TECHNICAL NOTE

(Doc Ref: 1368-WSP-00-XX-RP-CV-0002)

DATE:	09 June 2021	CONFIDENTIALITY:	Restricted
SUBJECT:	Alternative highway and drainage options for Roxton Road link (north)		
PROJECT:	[REDACTED]	AUTHOR:	Anthony Groom / Joe Leslie
CHECKED:	Livio Martelli	APPROVED:	Livio Martelli

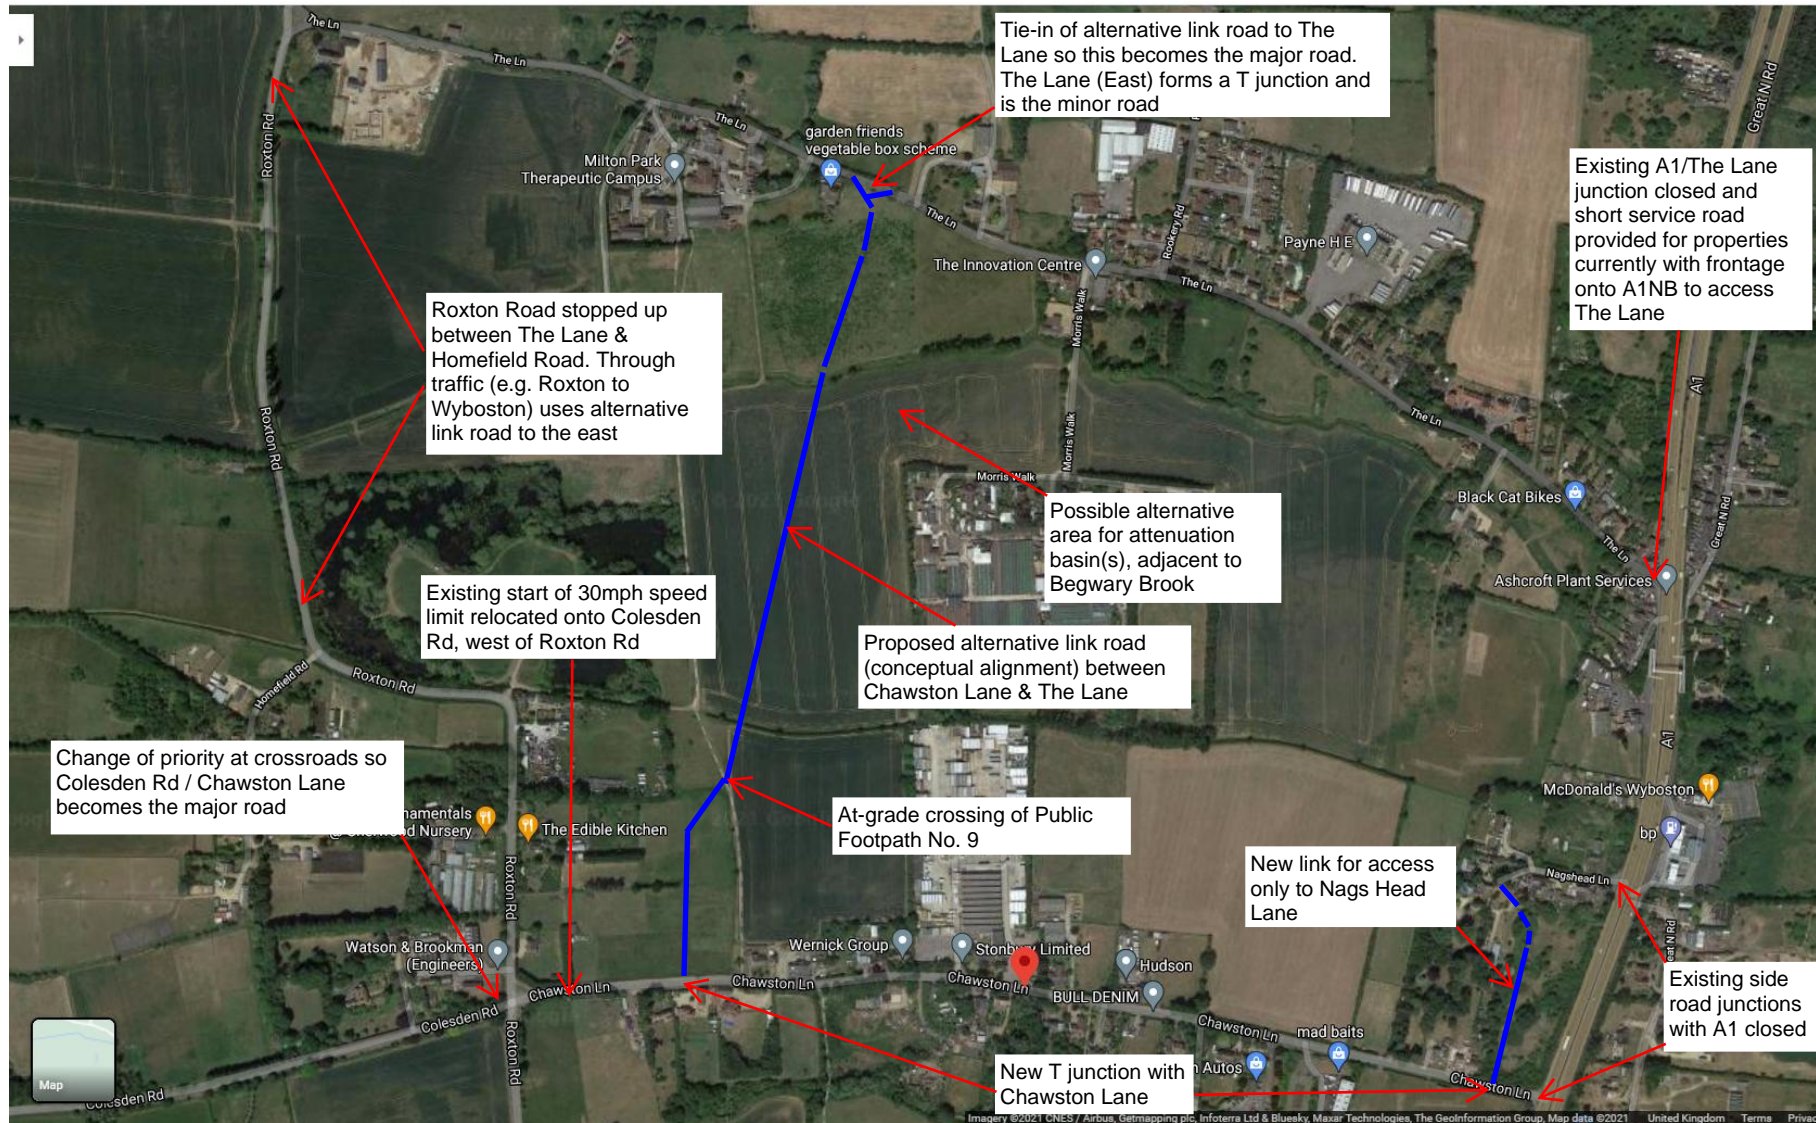
- 1.1.8 The WSP technical note suggests an alternative design for the horizontal alignment at the location of the double bend. This uses a 70m stopping sight distance and horizontal radii of 54m and 100m at the double bends. It states that this allows for more flexibility around the central section of the scheme without compromising forward visibility, swept path analysis or safety.

- 1.1.9 Whilst the use of the 54m radius bend may have a greater speed control effect on vehicles, it is applied over a shorter distance than the equivalent 64m radius used in the scheme design (approximately 56m compared to 77m) so may not have a sustained effect. The suggested use of the 100m radius would reduce the speed control effect when compared to the 64m radius used in the scheme design. The forward visibility along this section is also greater (it was measured from the PDF drawing provided as approximately 85m). Whilst the difference in speed control between the scheme design and WSP suggestion is likely to be marginal, MfS2 Cl. 8.3.8 and MfS1 7.4.4 imply both of these changes could either individually or in combination encourage higher speeds along the section from Chawston Lane to the first bend.

- 1.1.10 The 100m radius bend also starts closer to Chawston Lane and would result in the removal of approximately 30m of established hedge that would provide visual and noise screening between the new road and the residential properties on Nags Head Lane. It also brings the road closer to these properties. The new road in the scheme design is approximately 120m from the properties but this would reduce to 100m. The loss of part of the hedge would also result in a modest loss of habitat.

- 1.1.11 Other aspects of the design (carriageway/verges/footpaths width, kerb radii, 2m widening on curves, buffer zone width) are stated to have been replicated. This is not the case for the widening on the 54m radius bend, which measures (from the PDF copy available) as 7m. This would cause safety issues for two HGVs trying to pass one another. The extent of the earthworks replicates the original design, which is not an unreasonable assumption, but it does not fully do this through the realigned section and the overall extent of the earthworks and verge is approximately 1m narrower than shown for the original design.

- 1.1.12 It is stated that the attenuation basins associated with the road have been reshaped to increase their land usage efficiency. The overall area of each pond is stated as being retained to ensure their capacity. The areas of the two ponds in the scheme design, including the maintenance access berm around each is 1040m² and 1495m² (north and south of the Nagshead Lane access respectively). The reshaped ponds measure as 1048m² and 2287m². The smaller pond is obviously intended to be the same area and the small difference in areas is negligible. The reason for the increase in area of the larger pond is not clear. A small landscape planting area has been retained.

1.1.16 The total area values in Table 5 show that each case, with or without the landscape review, the scheme design requires less land than the WSP alternative.

1.1.17 The WSP design does require less land to be acquired from [REDACTED], but requires land from another landowner in order to achieve this.

- The two designs will both provide speed control at the double bend.
- MfS2 clause 8.3.8 and MfS1 clause 7.4.4 imply that the alternative design would not provide as much speed control as the scheme design, firstly because the first bend uses a larger radius and secondly the forward visibility around both bends is greater than required by standards. The impact of the shorter application of the tighter radius is probably marginal.

- The alternative design moves the road closer to existing residential properties.
- The alternative design requires the removal of at least 25m of existing hedge that provides a noise and visual screen to properties on Nags Head Lane.

- The alternative design does not reduce the area of land that Highways England would need to acquire permanently. It does reduce permanent land acquisition at Dove Farm, but requires permanent acquisition of land elsewhere to mitigate.

Drawing Title
**DRAINAGE ENGINEERING PLAN
REGULATION 5(2)(O) & 6(2)
SHEET 2**

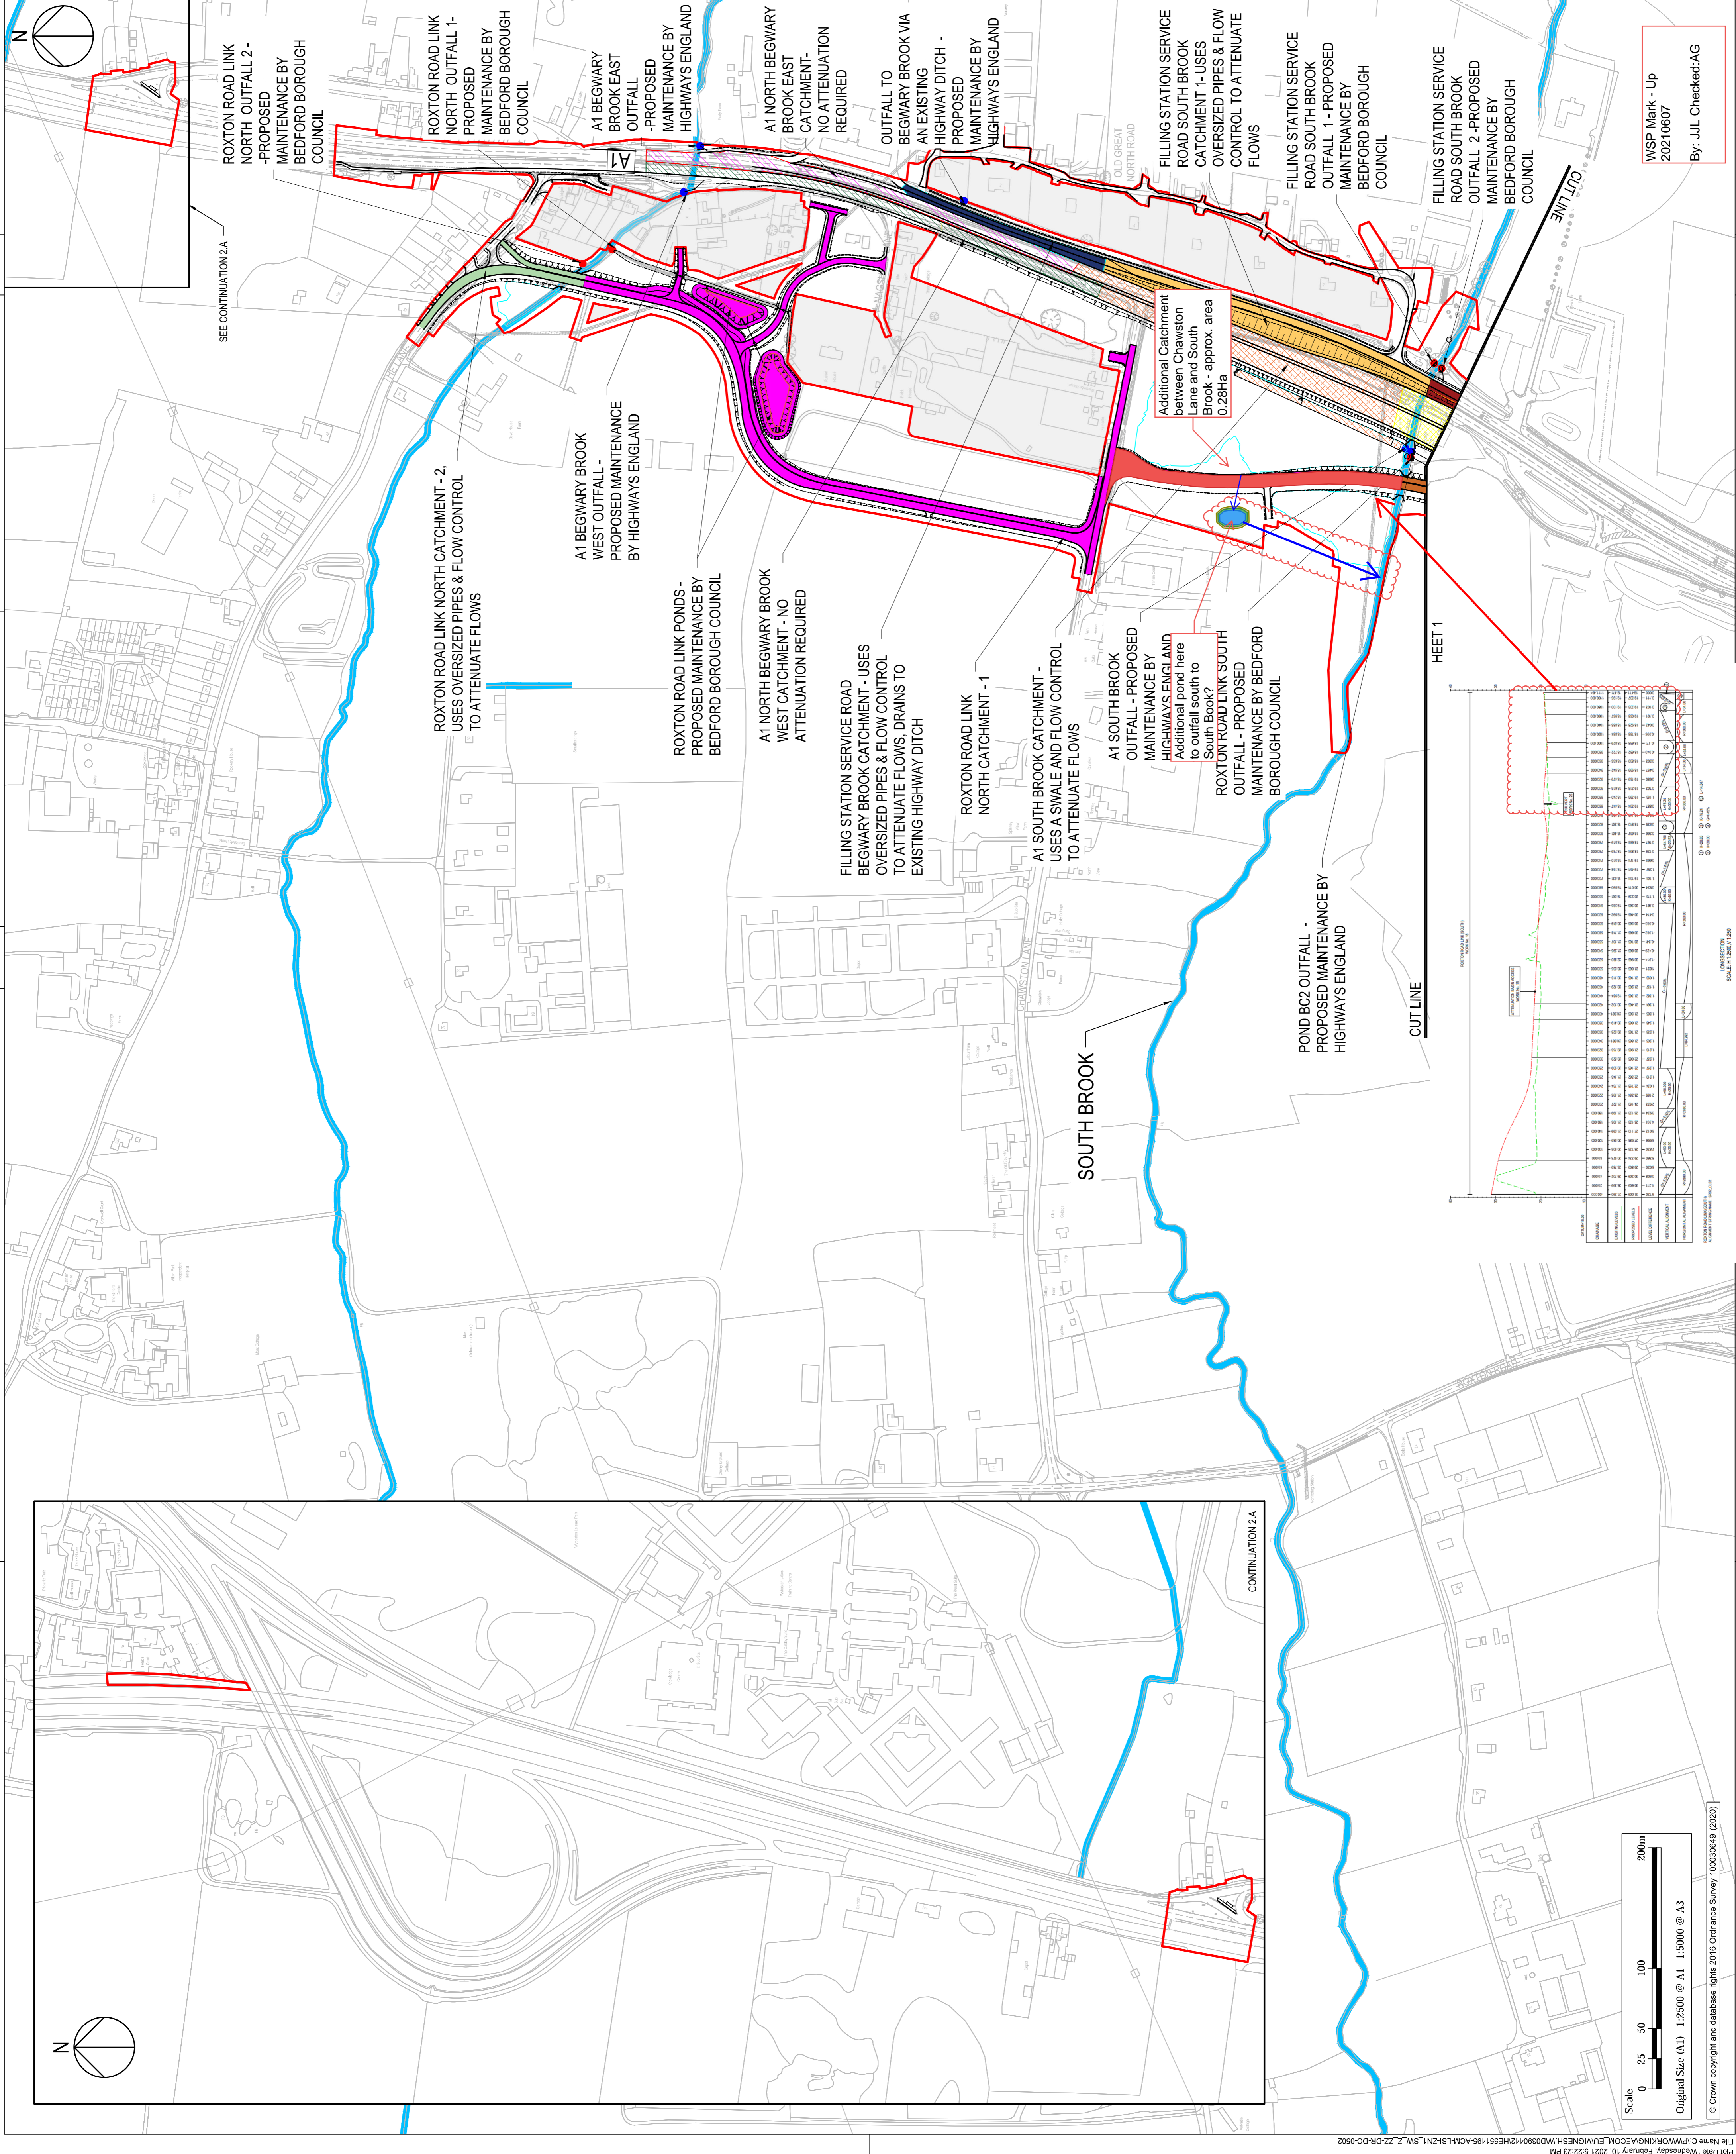
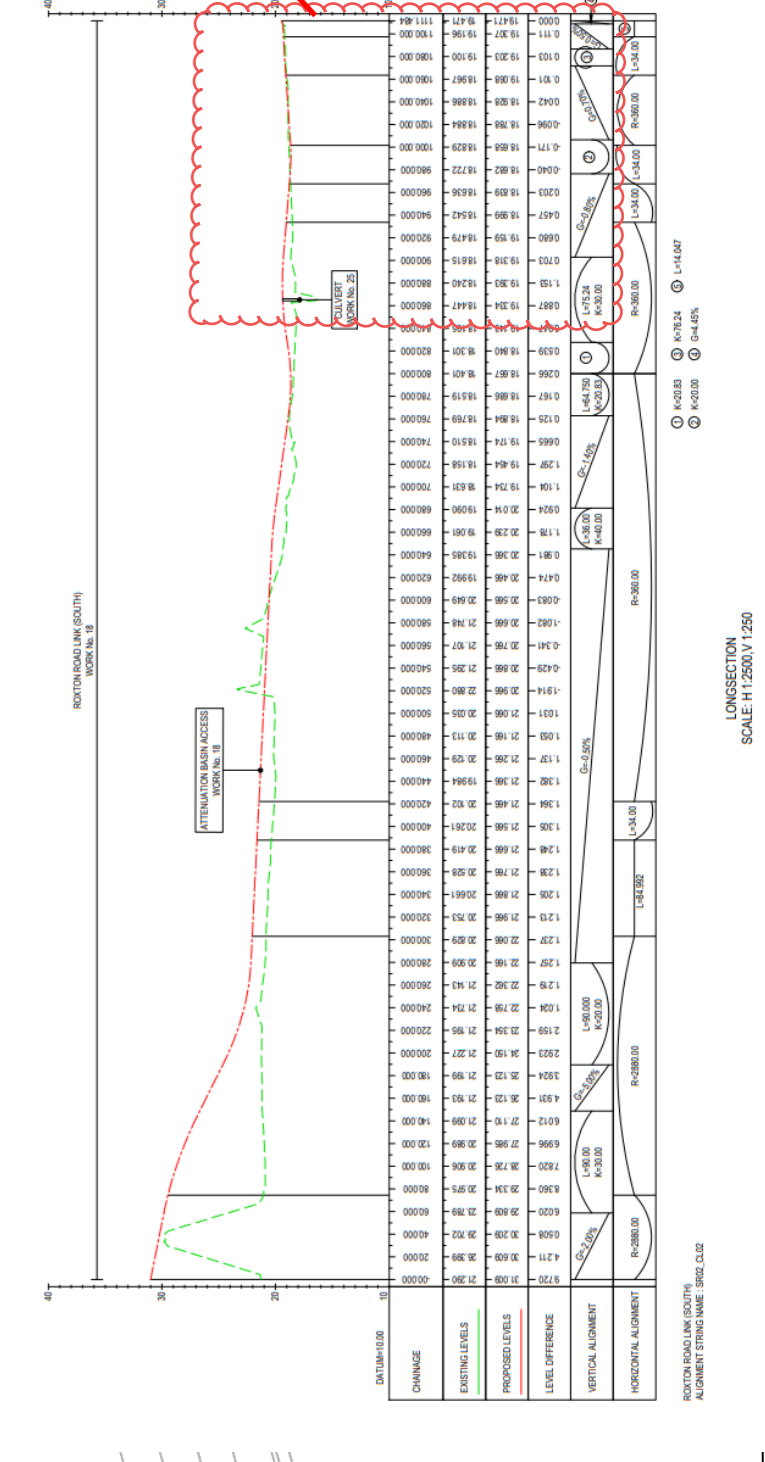
The location of the two ponds within the catchment would appear to be appropriate based on the Roxton Link Road (North) - Work No. 29a long-section found on plan HE551495-ACM-LSI-ZN1_SW_Z_ZZ-DR-DC-2418, as they are located at a low point of the proposed road catchment. However, on examination of the long-section, Roxton Road Link (South) – Work No.18 on plan HE551495-ACM-LSI-ZN1_SW_Z_ZZ-DR-DC-2417, a further sag/low point at approximate chainage 990m is noted which has prompted us to investigate an alternative outline drainage design (see plan at Appendix C). The main features of this alternative design would involve removing the impermeable area south of Chawston Lane (shaded red on Appendix C plan) from the current catchment 1 and providing an additional pond west of Roxton Road link (south), adjacent to the above low point and within the current order limits, to attenuate flows from the additional catchment area before discharging into South Brook. The size of this additional pond has been calculated as follows:

- i) South of Chawston Road the catchment comprises approx. 0.28ha of impermeable area. Based on a source control storage estimate utilising FSR data in Microdrainage and an assumed discharge rate of approx. 0.6 litres/sec (from the HR Wallingford Greenfield estimation tool), a storage requirement of 220m³ would be required in a 1 in 100 + 40% climate change allowance storm event.
- ii) At a depth of 1.5m (including a 300mm freeboard) and 1 in 3 side slopes a pond of top area of 335m² would appear to be sufficient for this additional pond.

- iii) Referring to the Microdrainage output in Appendix D, the calculations undertaken are considered to be a conservative approach and the sizing could be reduced if further design detail was provided by HE.

Can HE please clarify why an alternative drainage design, as illustrated on the plan included in Appendix C, has not been considered and why their proposed drainage design for Roxton Road link (north) is the most appropriate?

It is anticipated that this alternative design would enable the size and associated land-take of Ponds 1 & 2 to be reduced and could enable the proposed alignment of Roxton Road link (north) to be amended such that the impact on our client's land would be reduced and land-take from other landowners identified in the HE Technical Note in Appendix A could be reduced.
